This is to certify that TOP OF EXCHANGE LLC Monaghan Woodworks Inc.
has permission to Interior tenant fit-up of entire 2nd floor (permitted by 705)
AT 85 EXCHANGE ST (L 032 D004001)

Addendum #2 to Plans and Specifications For: Wall base and Metal door frames

85 EXCHANGE STREET, PORTLAND ME
 3RD FLOOR RENOVATIONS

Addendum #3 to Plans and Specifications For:

DRAWING _____
DRAWN BY BSI
CHECKED BY BSI
SCALE 1/8" = 1'-0"
REFERENCE DRAWING H2.00
HVAC
NETWORK ROOM
EXHAUST FAN

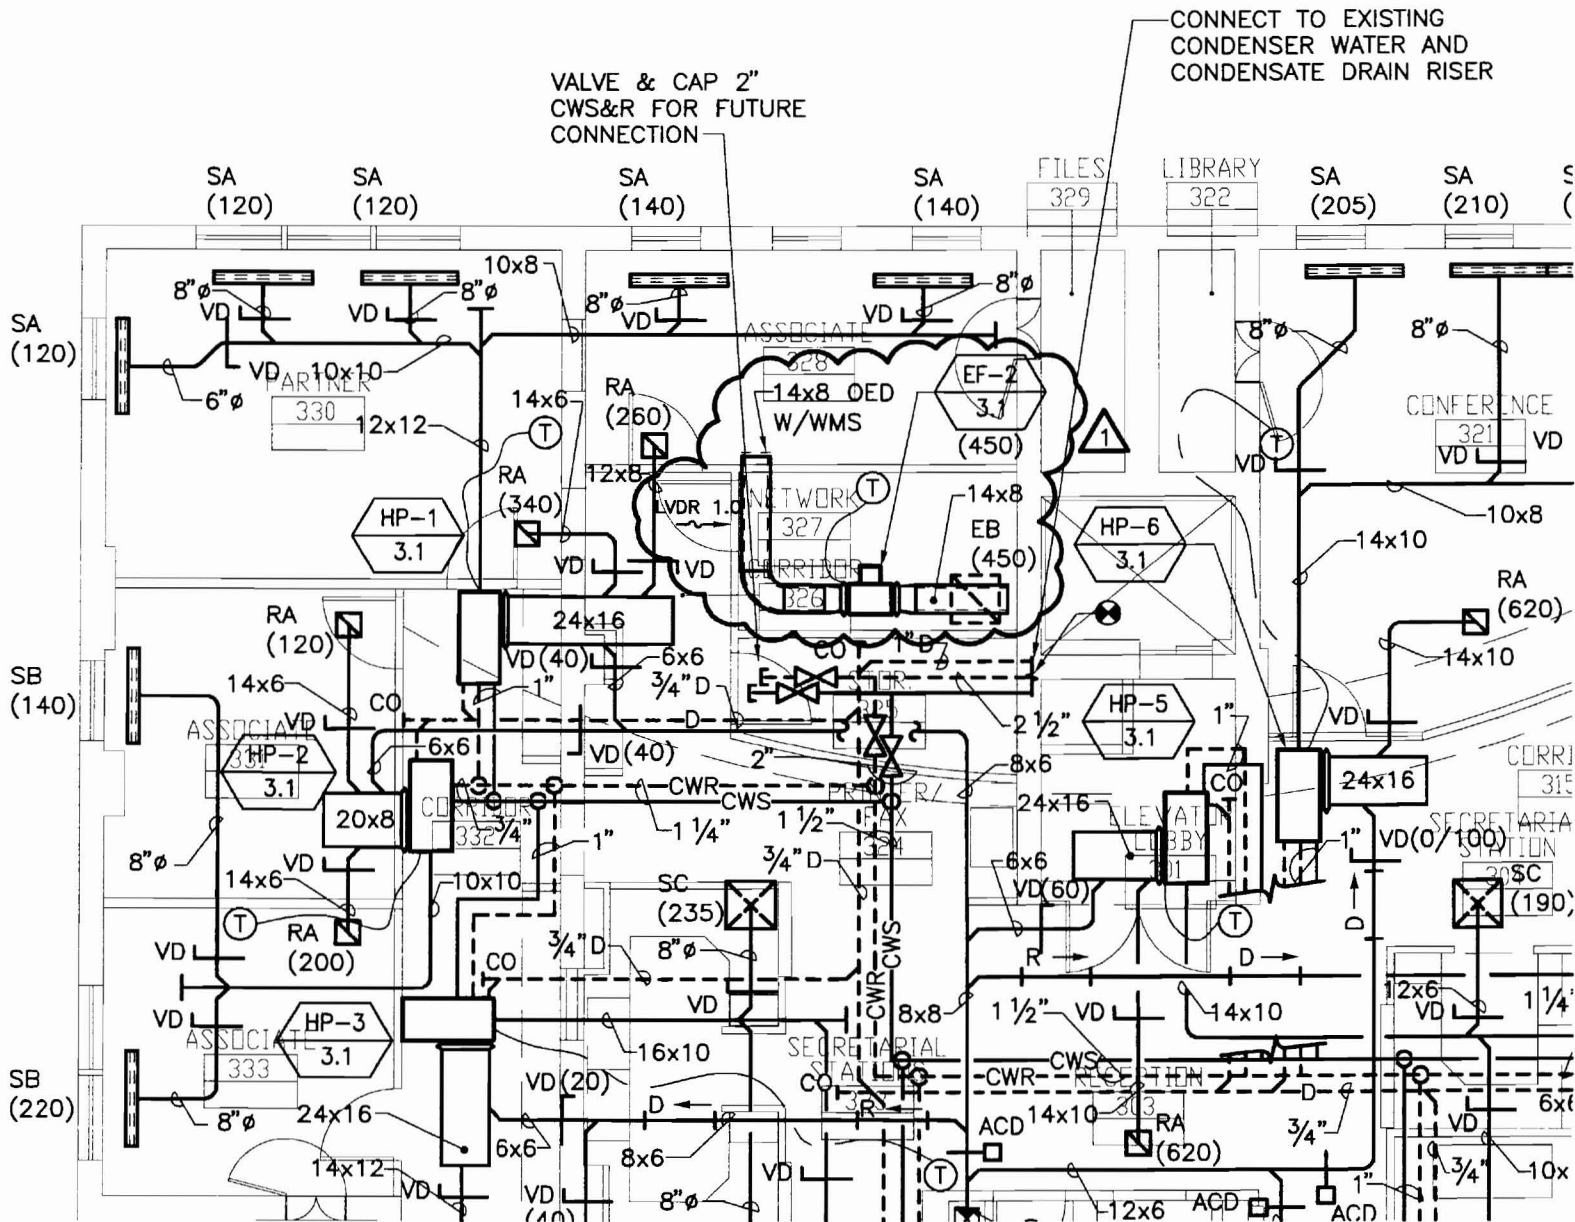
Delete HP-10 and replace with an exhaust fan.

SKA-01
 REVISED RCP

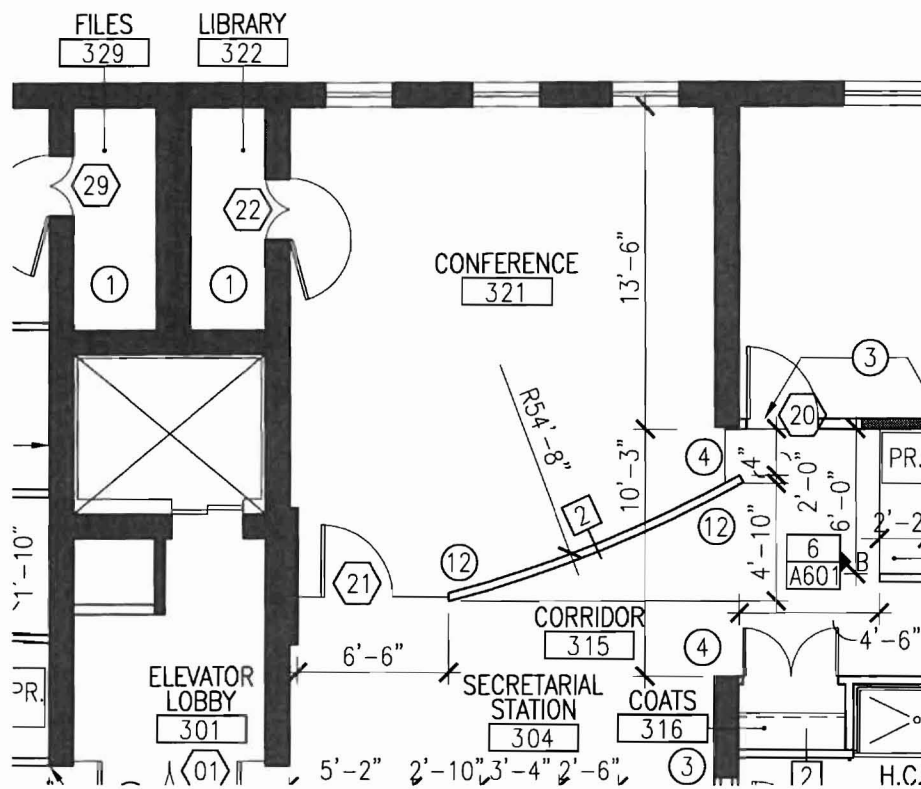
SKA-01: Delete curved GWB soffit and light cove in corridor #332 and file area #335. Provide additional lighting as indicated on sketch.

SKA-02
 REVISED CONF. RM. 321

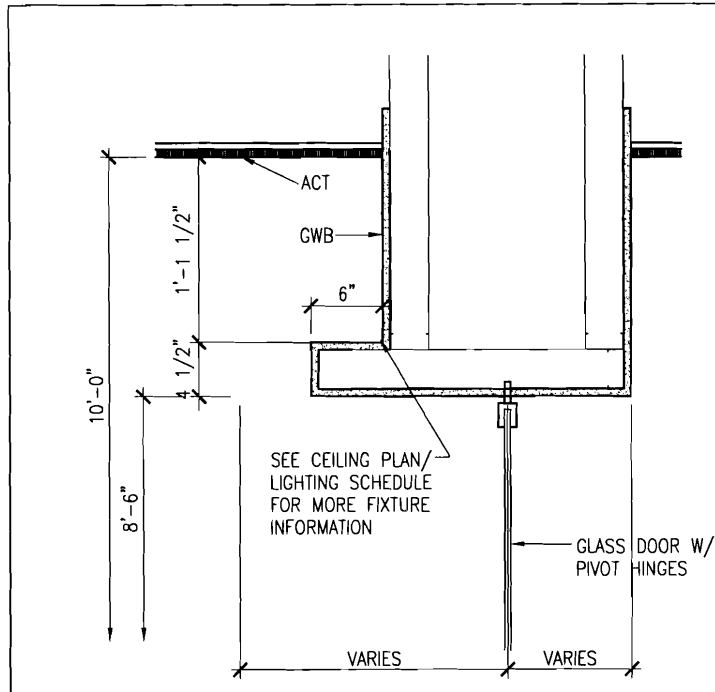
SKA-02: Delete GWB wing wall in conference room #321.

PARTITION TYPES

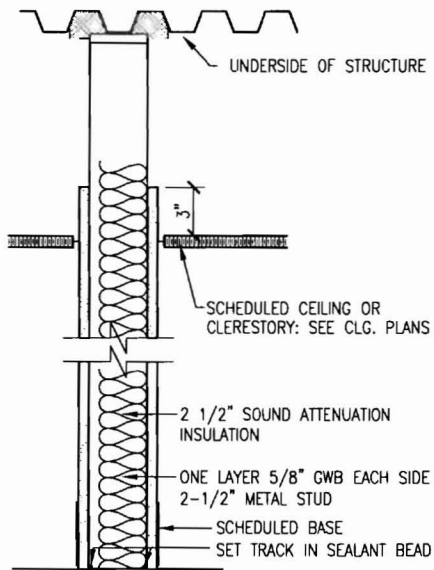
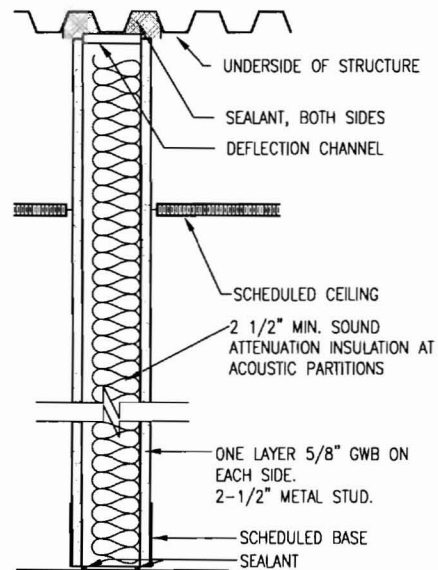
SKA-04: Partition types. Please note that all partitions between offices, new and existing, are to be type #2

SKA-05
 REVISED RCP

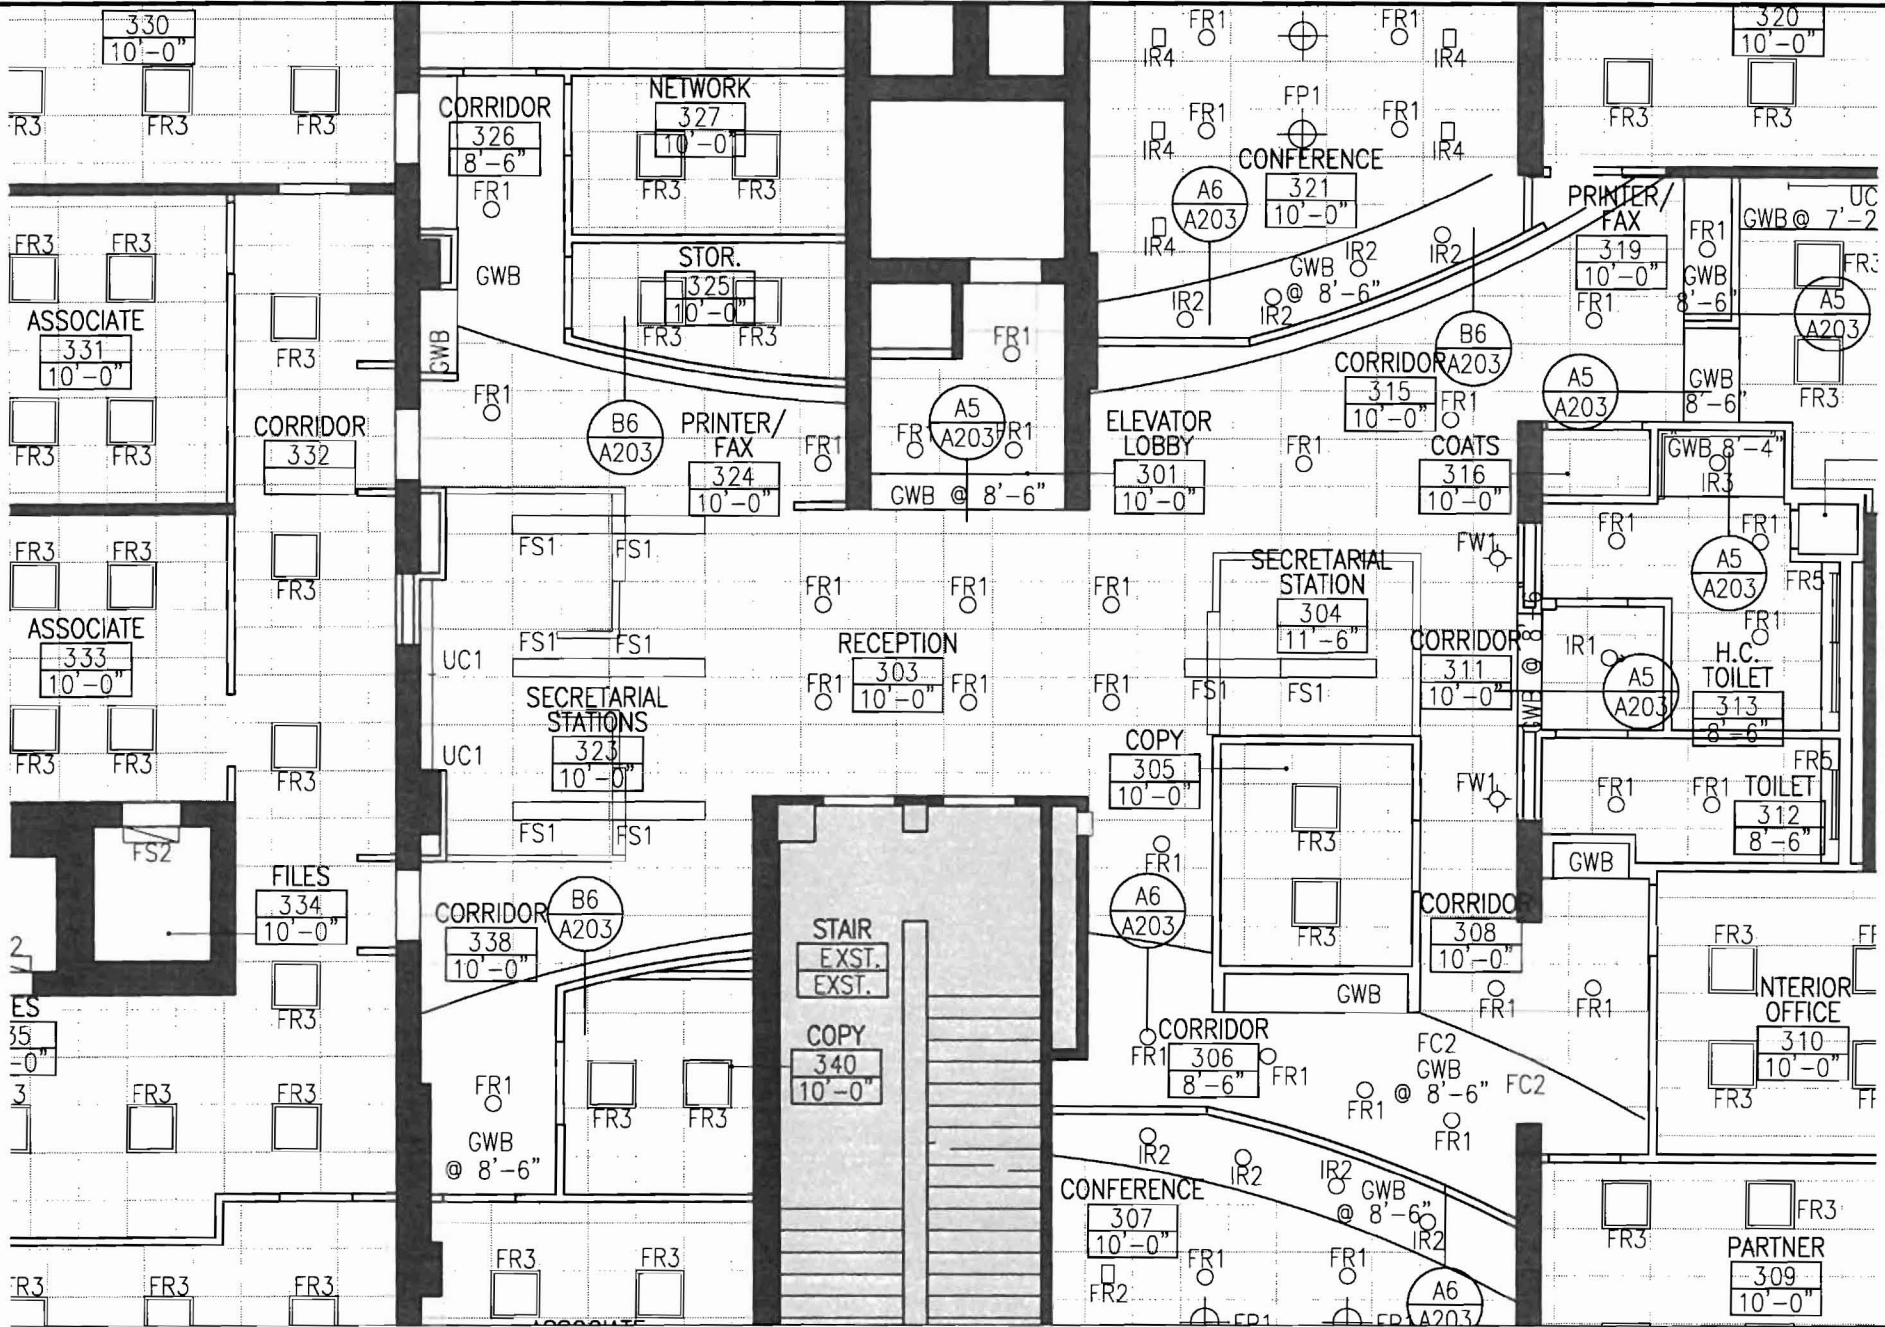
SKA-05: Alternate lighting, If the light cove is deleted along the curved GWB soffit additional light fixtures will need to be added to the ACT ceiling. Provide a price to provide the additional fixtures indicated on the sketch.

SKA-06
 ADA BATHROOMS

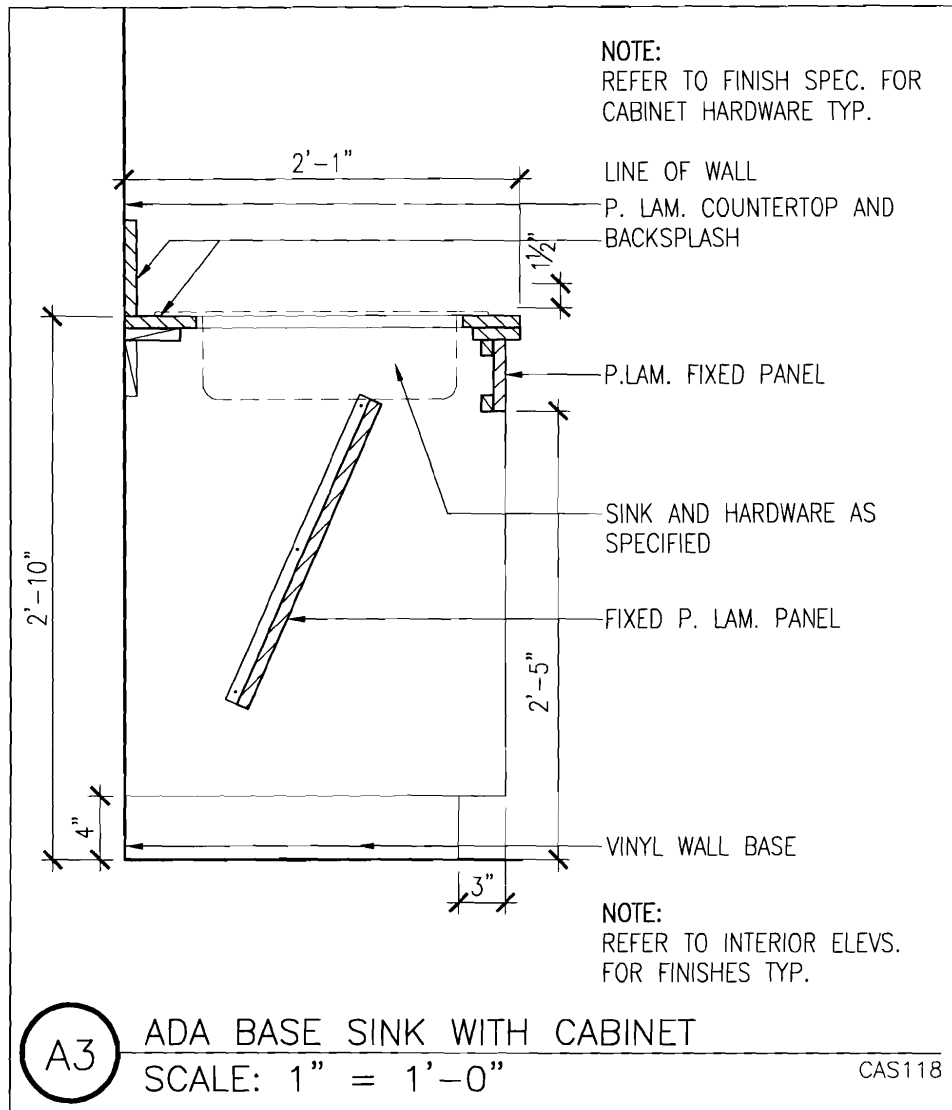
Bathroom revisions to comply with ADA codes.

REFERENCE DRAWING
H2.00

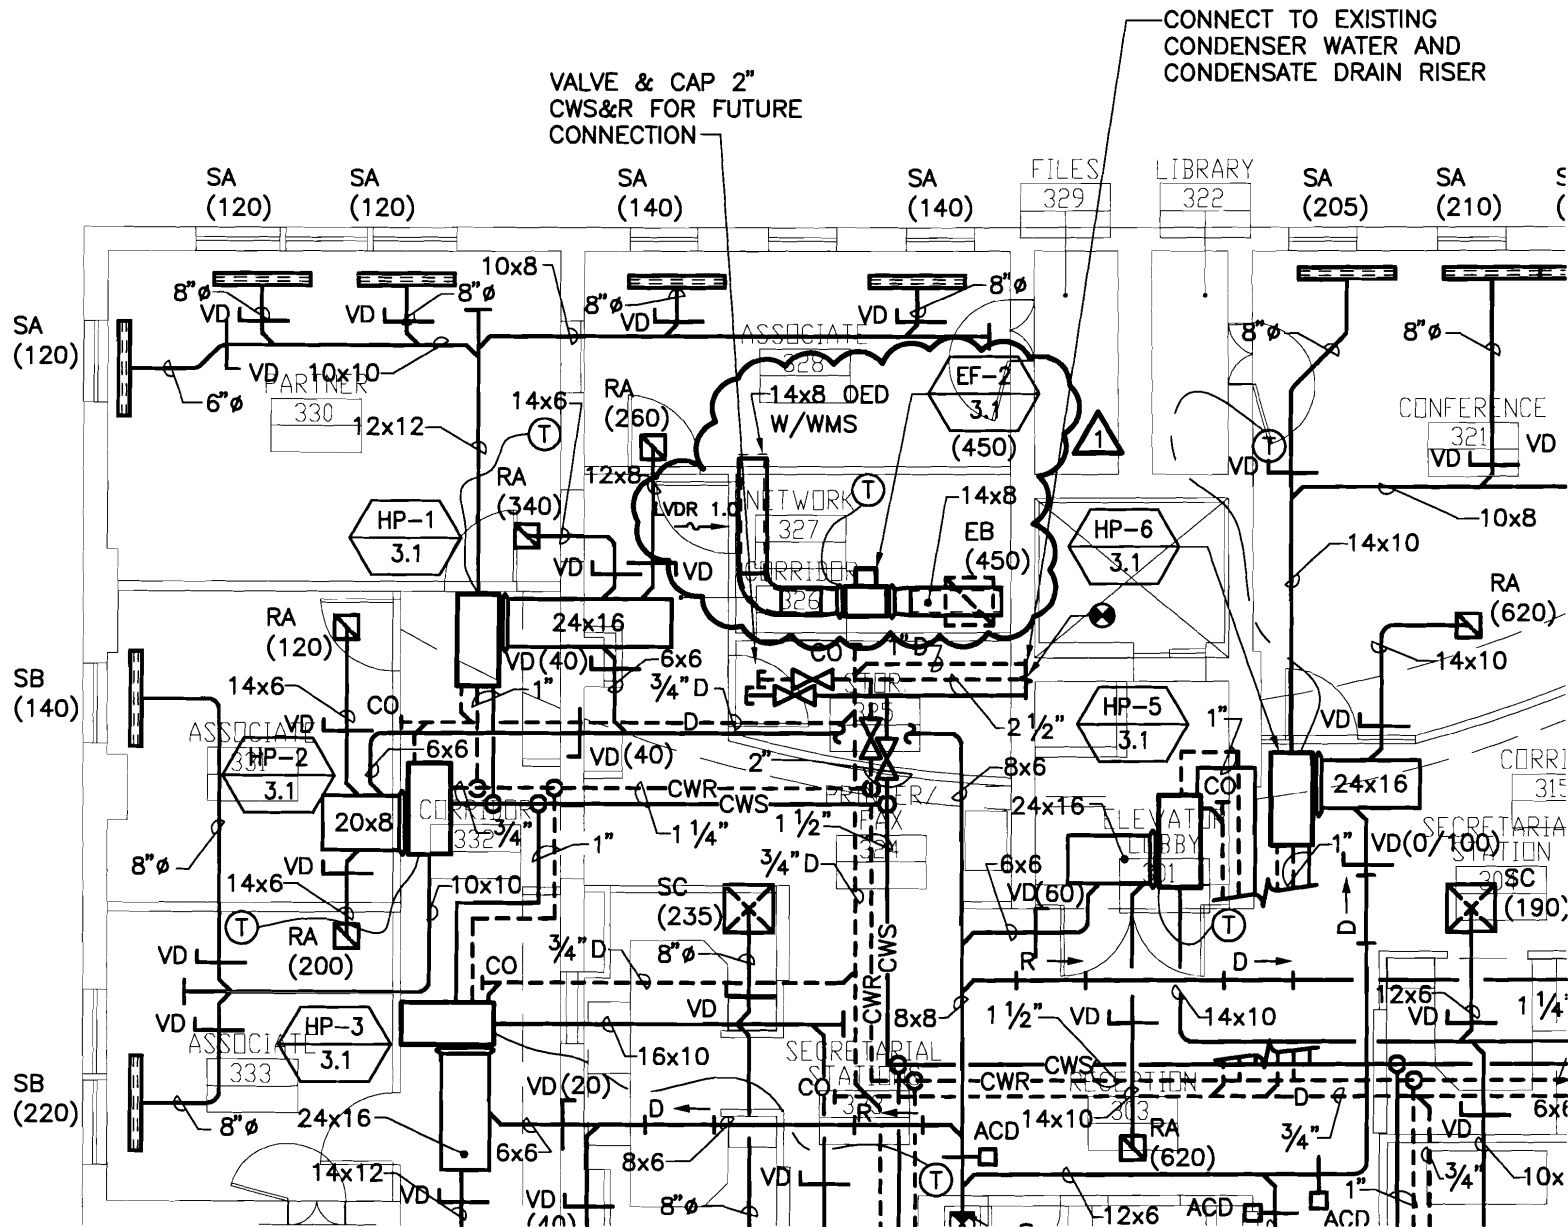
Delete HP-10 and replace with an exhaust fan.
